## MEMORANDUM

**FILE REF.:** CP CASE # 16-5090 Turquoise Trail North Conceptual Plan

RCS-Turquoise Trail South I, LLC, Applicant, Sommer Karnes & Associates LLP, Agent, request Conceptual Plan approval to phase the previously approved Turquoise Trail North residential subdivision (290 dwelling units on 101.49 acres) into 8 phases, to modify the approved housing types, and to re-designate the commercial lot to a multi-family lot with 23 dwelling units.

PHASING PLAN

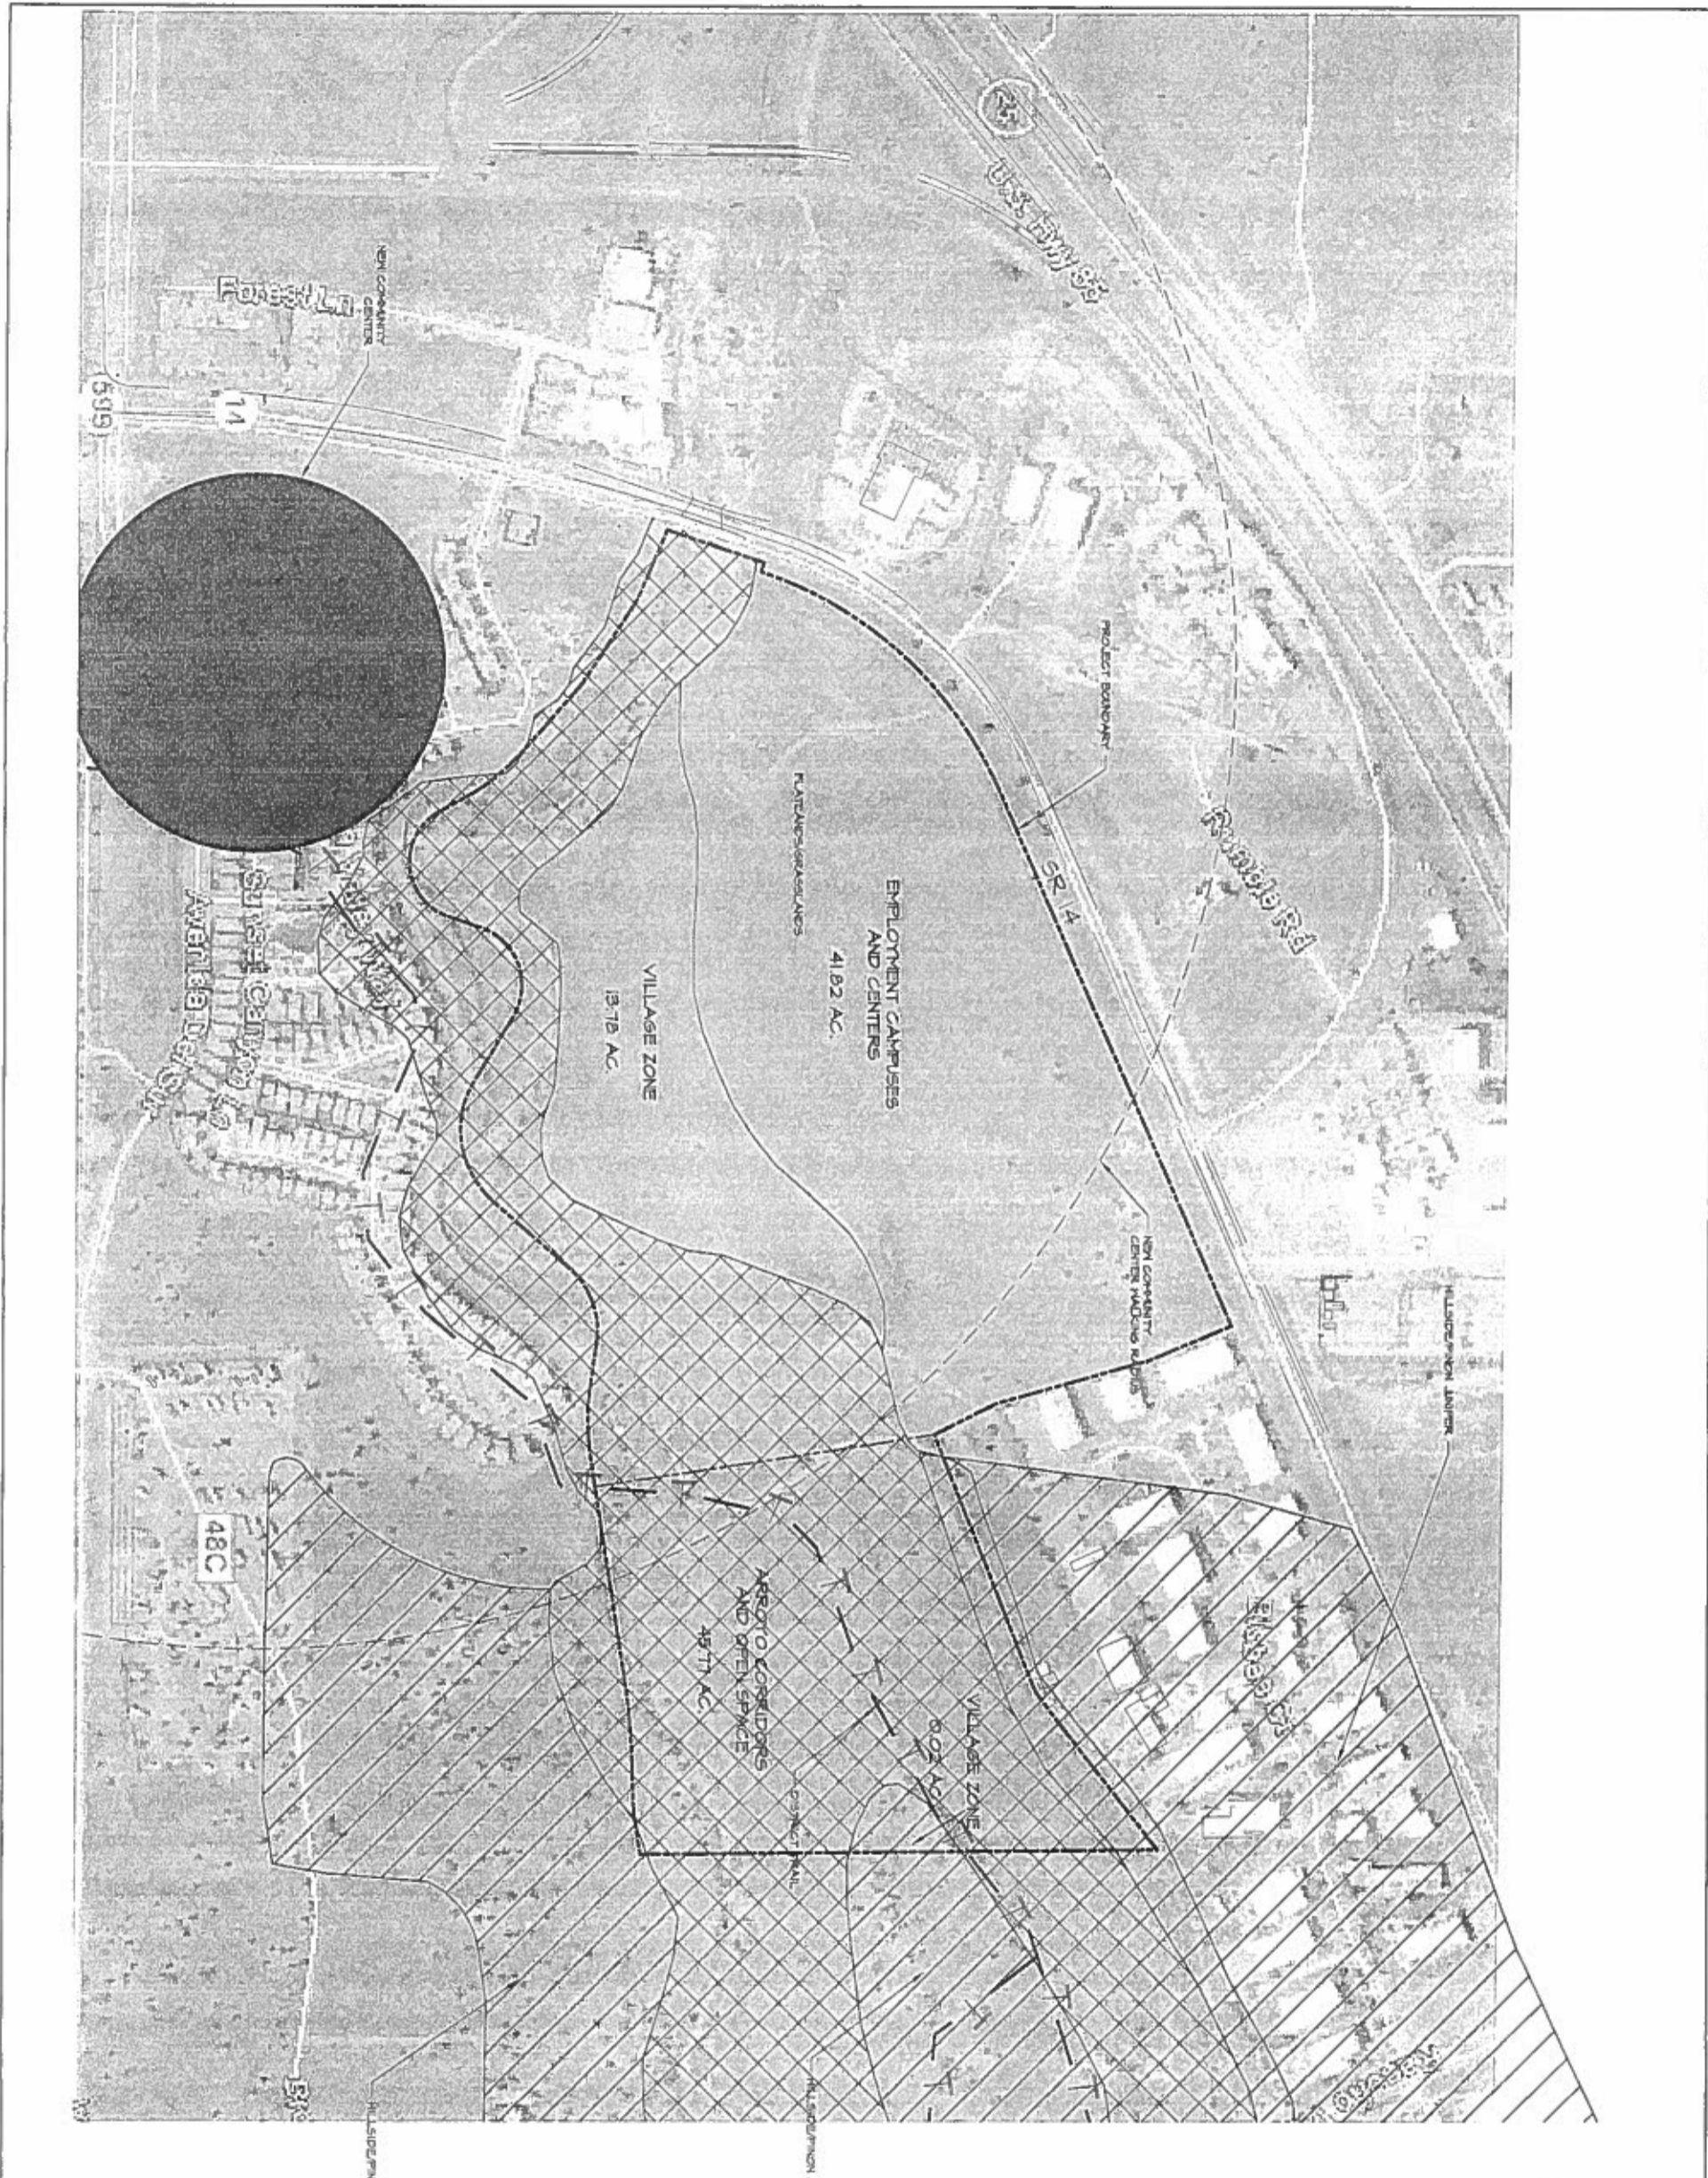
Turquoise Trail North is divided into 8 phases as shown on Plans and Drawings Sheet 3.
